Modification Recommended Service Note

J7201A Attenuation Control Unit, DC to 6 GHz, 0 to 121 dB, 1-dB Steps

Serial Numbers: MY59400001 to MY61410090

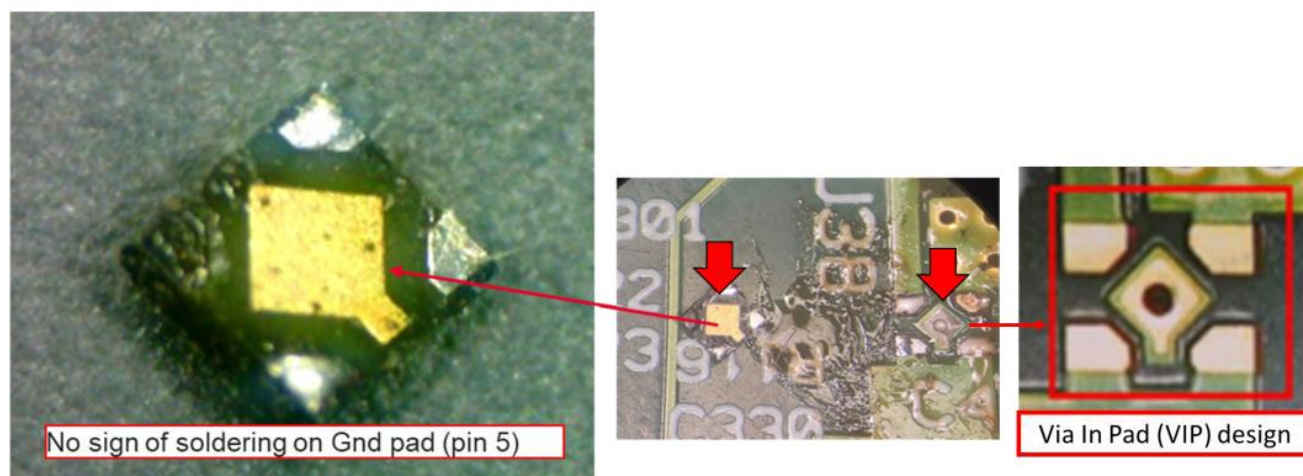
The instrument is unable to boot up and is stuck on the boot-up screen as follows. It is not functioning.

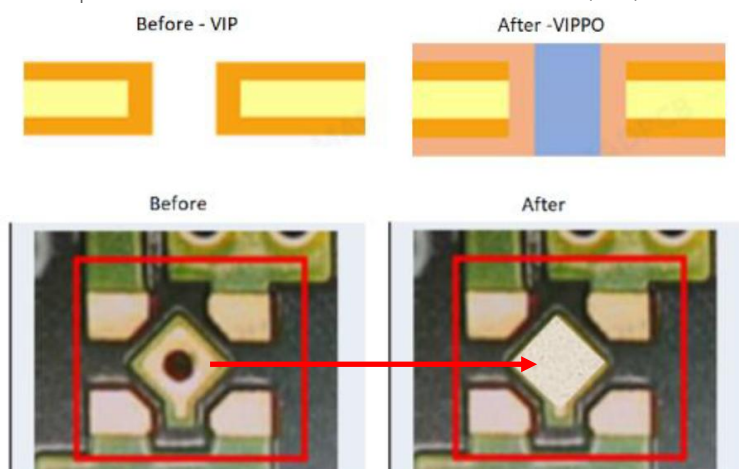
Failure analysis had indicated defective on P0600-63004 board where insufficient solder was observed at 2 locations. The insufficient solder was due to Via in Pad (VIP) where the melted solder had flown to the secondary side of the PCB.

The improvements were made from Via in Pad (VIP) to Via in Pad Plated Over (VIPPO) as per below.

The improved PPMC board have Serial number P06006300423**2413**000007 onwards.

Replace PPMC board P0600-63004 with PPMC board serial number P06006300423**2413**000007 onwards where 13 is the work week and 24 is the year.
